Lloyd's Register of Shipping. No. 19343.

Ship's Name S/S "EMPIRE CENTAUR" (Wm Gray & Co. 1134) Official No. 168946.

Memorandum of alterations reported since ship was surveyed for assignment of Load Lines in August 1942

2ND DECK.

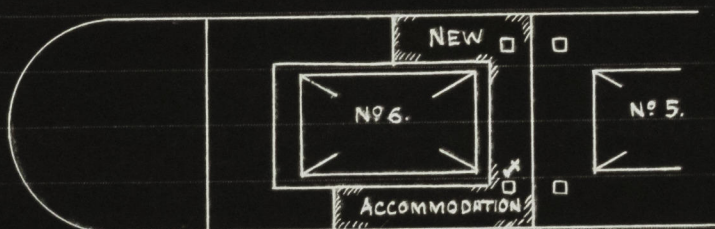
- 4/ Wood covers 2½" thick fitted to Nos. 1 & 6 'tween deck hatchways i.e. All 'tween deck hatchways are now fitted with wood covers.
- 5/ One small escape hatch at fore end of No 6 'tween deck (stbd) has been removed and deck plated over.

✓ ESCAPE HATCH REMOVED
